Mandatory Referral for the Capital Crescent Surface Route, MR2019004

DESCRIPTION

The Capital Crescent Surface Trail (CCST) project would construct two-way separated bike lanes along Bethesda Avenue and Willow Lane in Downtown Bethesda, provide a diagonal, protected crossing for bicyclists at the intersection of Bethesda Avenue and Woodmont Avenue and provide a protected phase for trail users to cross Wisconsin Avenue.

Staff recommends **approval with comments** on the Mandatory Referral for the Capital Crescent Surface Trail.

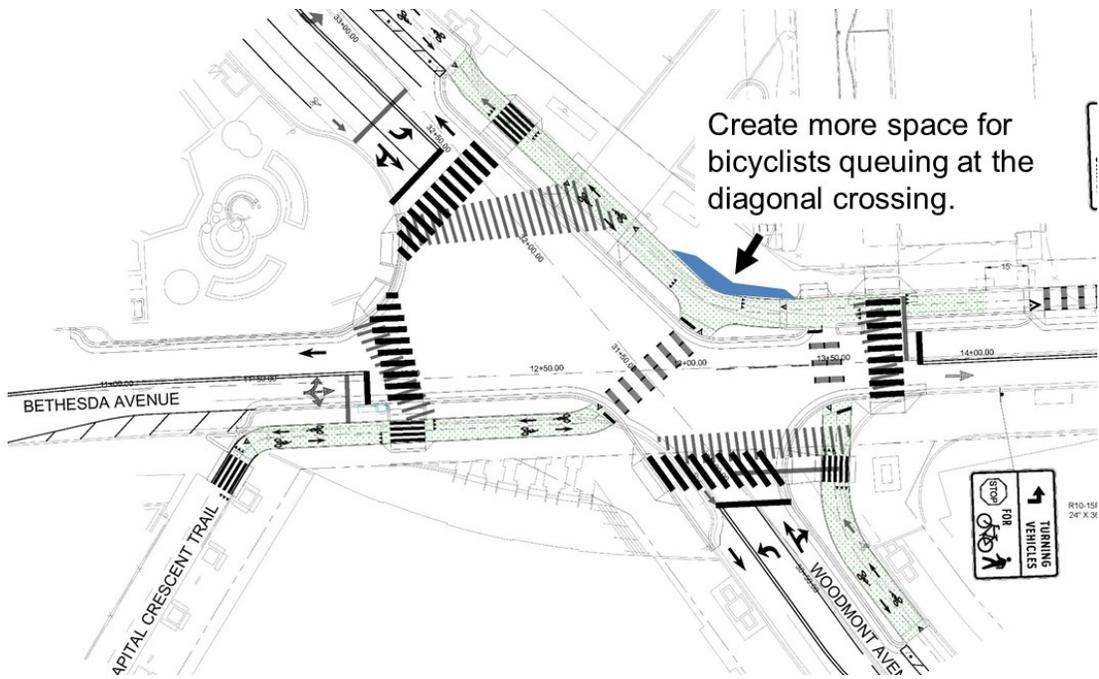
- 3. Consider the following changes to the curb ramps at the intersection of Woodmont Ave and Bethesda Avenue:
 - d. East Leg: Widen the curb ramps on the north side of Bethesda Avenue to a minimum of 10 feet.

- e. West Leg: Shift the crosswalk on the south side of Bethesda Avenue to the west to align with the crosswalk on the north leg and to reduce the crossing distance. Also, consider enlarging the plaza at the northwest corner by eliminating southbound right turns.

- f. North Leg: Shift the crossing to the north to where the lane markings are located so that the curb ramps align. This will reduce the crossing distance.

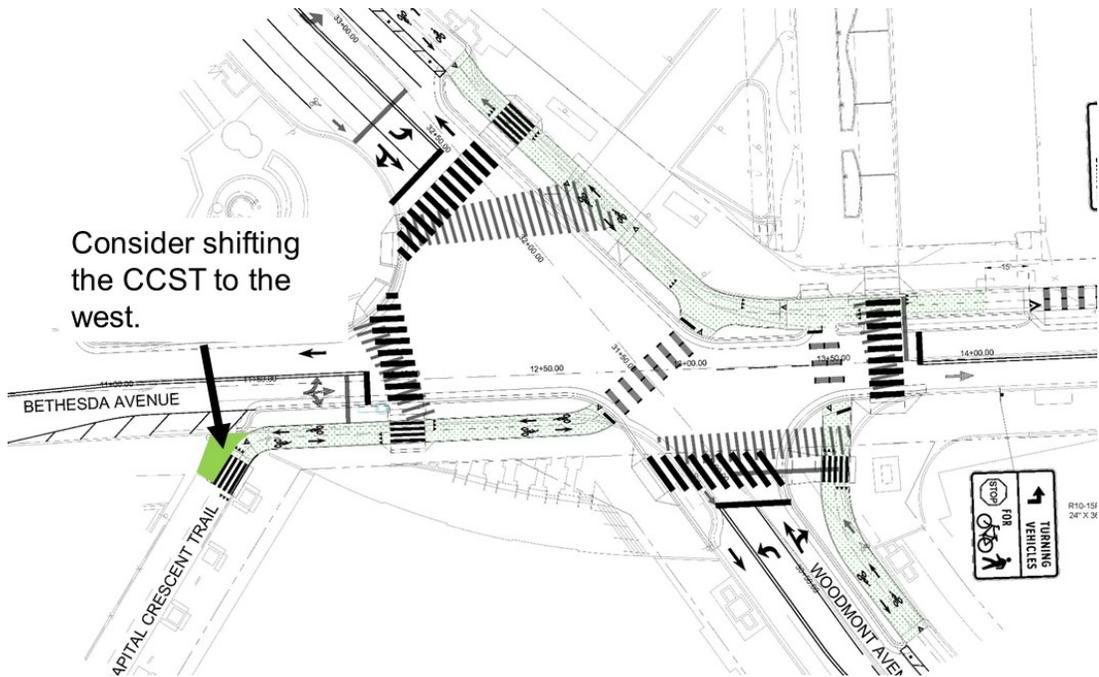
- 4. While there is a substantial queuing area for bicyclists at the southwest corner of the intersection of Bethesda Avenue and Woodmont Avenue, the queuing area at the northeast corner is limited and will likely back up, obstructing pedestrian and bicycle flows between Bethesda Avenue and Woodmont Avenue. Consider ways to create additional queuing space to accommodate bicyclists queuing at the northeast corner, such as creating more space for bicyclists to queue at the diagonal crossing.

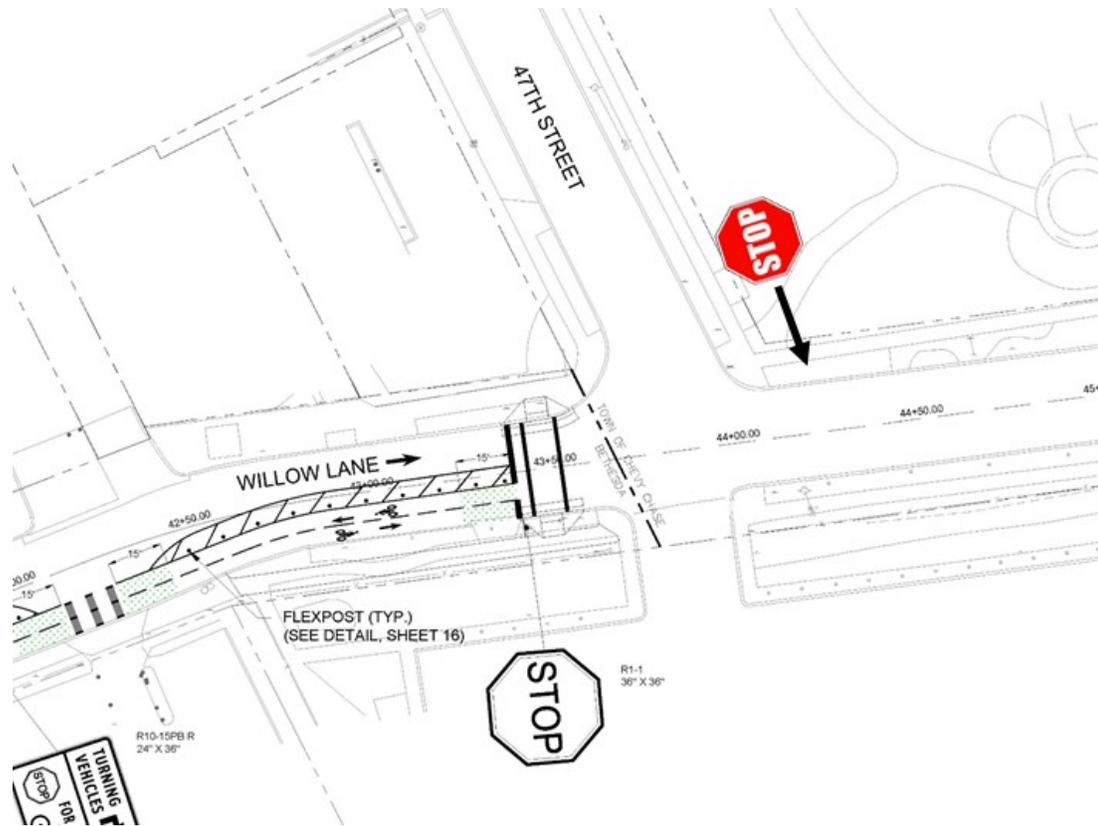
5. Consider shifting the CCST at the connection to the existing portion of the CCT to reduce potential conflicts between pedestrians and bicyclists in gathering areas on both sides of the Capital Crescent Trail. Coordinate final design and connection point with the Department of Parks.
